**Proposal #28: 6640-00-72, WISC 2020 269
Columbus - Princeton
Columbia County Line - STH 44
STH 73
Green Lake County**

This is Addendum No. 01, which provides for the following:

ADDENDUM NO. 01

SECTION CORNER MONUMENT AND LANDMARK REFERENCE MONUMENT DETAIL

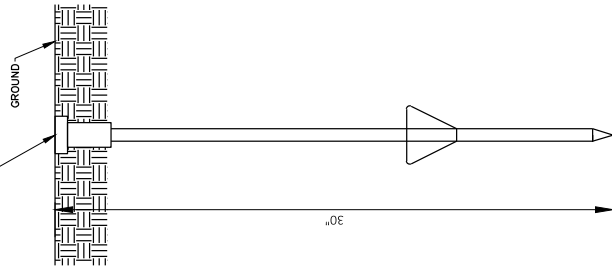
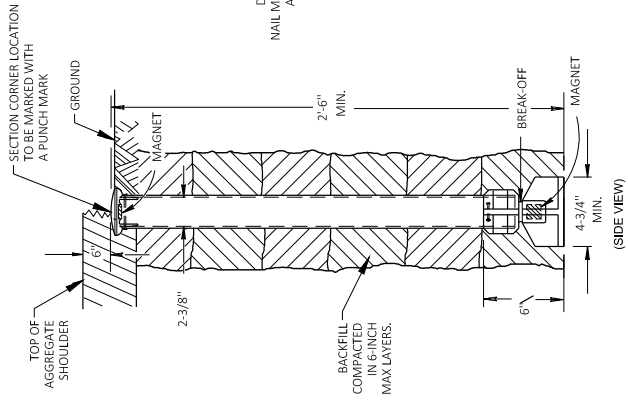
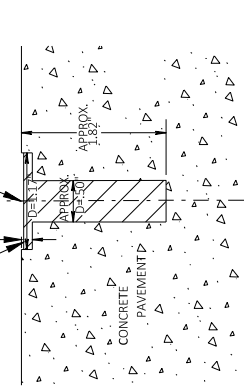
Added Plan Sheets	
Plan Sheet	Plan Sheet Title (brief description of why sheet was added)
6a	Construction Details (Added Section Corner Monument and Landmark Reference Monument Detail)
35A	SDD – Landmark Reference Monuments and Covers

Locate the exact position for the monument on the asphalt pavement. Drive the Berntsen Steel Nail Marker into the pavement until the top of the Steel Nail Marker is countersunk below the surrounding finished asphalt pavement as shown on the plan details.

Drill a hole in the finished concrete pavement using a Berntsen Survey Marker Countersink Drill Bit, Item # BPMDRL. Insert the ribbed plastic expansion plug into the drilled hole. Tap the brass marker stem into the expansion plug until the top of the brass marker is countersunk below the surrounding finished concrete pavement as shown on the plan details.

Install according to the pertinent provisions of standard spec 621.3 for Non-Driven Aluminum Monuments and the plan details.

Addendum No. 01
ID 6640-00-72
Revised Sheet 11
May 7, 2020

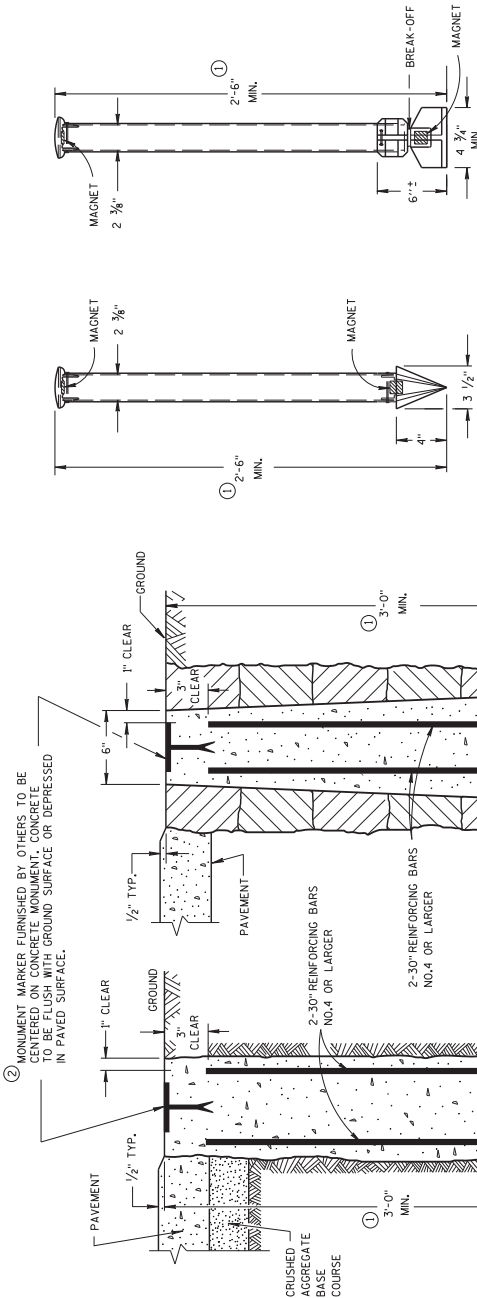
Revised Plan Sheets	
Plan Sheet	Plan Sheet Title (brief description of changes to sheet)
9	Miscellaneous Quantities (Removed quantity for Base Aggregate Dense 1 ¼-Inch)
10	Miscellaneous Quantities (Revised quantities for Traffic Control items)
11	Miscellaneous Quantities (Added quantities related to Landmark Monuments)
